Joint Meeting of the RID Committee of Experts and the
Working Party on the Transport of Dangerous Goods

United Kingdom interpretation of construction requirements applicable to the opening ends of Vacuum-Operated Waste Tanks (VOWTs)

Transmitted by the Government of the United Kingdom

- (a) Manual hand wheel door clamps.

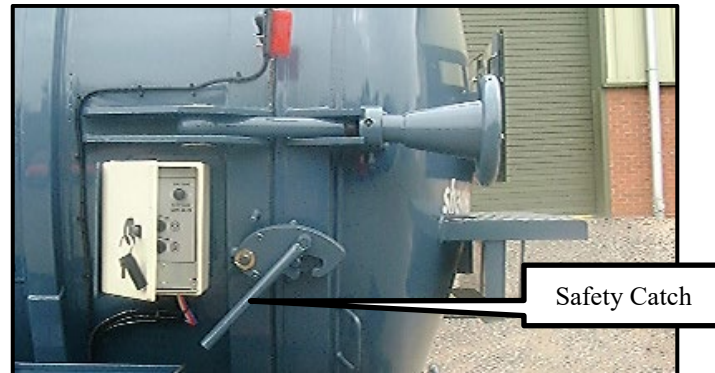
The clamps are protected by the substantial brackets on the tank and door from damage during a roll-over. In the event of a roll-over occurring, the hand wheels are designed to fracture and leave a nut securing the door in place.

It should be noted that, as required by ADR 6.10.3.5 (d), the above locking arrangement incorporates a safety device to prevent the door opening when there is still residual pressure in the tank.

6. In our opinion the examples shown in (a) and (b) above would seem to meet the requirements of 6.10.3.5 (e). In respect to example (c) however, given the door clamping mechanism would appear to be vulnerable to damage and allow the door to be forced open in the event of a roll-over incident, in our view this design would not seem to meet the requirements of 6.10.3.5 (e) unless additional measures were to be put in place to protect the locking mechanism.

(b) Hydraulic wedge type door clamps.

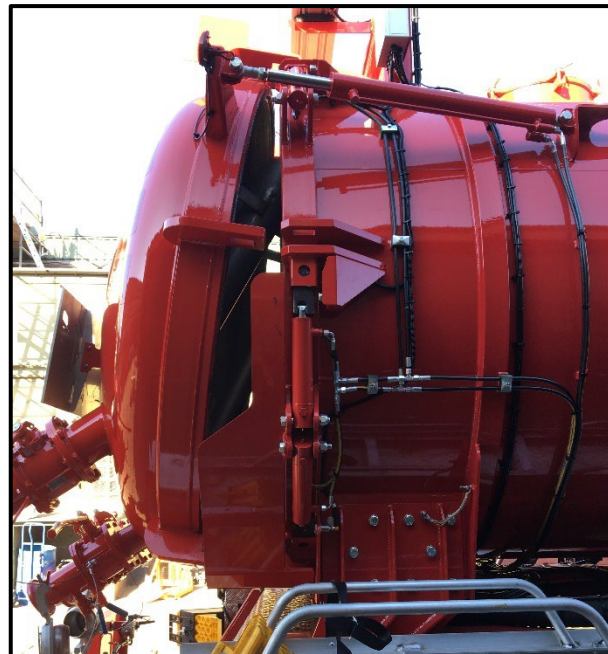
This type of clamp is fully automatic, controlled by hydraulic linear actuators. The wedge on the end of the ram is guided through slotted brackets on the door and the end of the tank vessel and the wedge pulls the seal tight onto the sealing face. The hydraulic oil is locked in the rams preventing the rams from opening. The position of the rams around the door ring is likely to ensure that the openable end is not forced open in the event of a roll-over and allow the loss of any products being carried.
